UNITED STATES PATENT AND TRADEMARK OFFICE

APPLICATION NO.	FILING DATE	FIRST NAMED INVENTOR	ATTORNEY DOCKET NO.	CONFIRMATION NO.
10/088,470	08/21/2002	Tetsuya Takashima	MATS:036	2935

Office Action Summary

FIG. 4

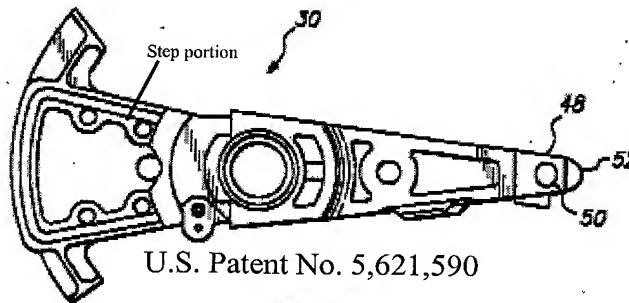
5. Claim 1-9 are rejected under 35 U.S.C. 103(a) as being unpatentable over Phillips et al. U.S. Patent No. 5,600,516 in view of Pace et al. U.S. Patent No. 5,621,590.

Referring to claims 1-10, Phillips disclose an actuator (72), comprising a pair of yokes (24) opposing to each other via a first specified space, a magnet (100) fixed to at least one of said yokes, and a carriage holding a coil on one end thereof against said magnet via a second specified space and rocking about a rotary shaft. wherein said carriage comprises two coil fitting arms (86) opposing to each other and at least one through-hole (104 and 106), piercing from bottom to top of said stepped portion, whose size is larger at the bottom than at the top (see fig. 6 and 6a), said coil disposed between said two coil fitting arms (86), and a holding member (90) for securing said coil fitting arms, said through-hole (104) and said coil. Also Phillips discloses and said step portion but doesn't disclose the two coil fitting arms having a step portion. However, Pace disclose a support coil member (34) having a step portion with holes for the purpose of supporting coil (32). Also disclose said through-hole (104) is formed at boundary portion between said coil fitting arm and the use of resin for encapsulation of the coil.

It would have been obvious to one having skill in the art at the time the invention was made to modify Philips' invention and made a step portion with through-hole and use resin for encapsulation of the coil for the purpose of support the coil as Pace disclose.
